Service Bulletin

No. : OST-US005

Model: AVR-2307, AVR-2307CI

Subject: Service Manual Part Correction

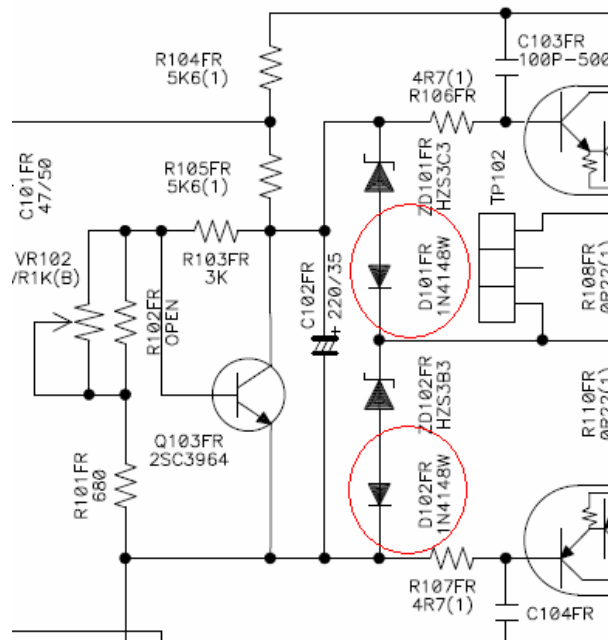
Symptom: Diodes D101 and D102 (FL, FR, C, SL, SR, SBL and SBR) are shown as 1N4148W. The part list shows a different part name (KDS160) and part number (00D 960 0197 000). This information is incorrect.

Solution: Use the part number listed in the part section when ordering replacement D101, D102 (FL, FR, C, SL, SR, SBL and SBR) diodes.

Ref#	Description	Part Number
D101, D102	00D 963 0355 401	KDS4148U
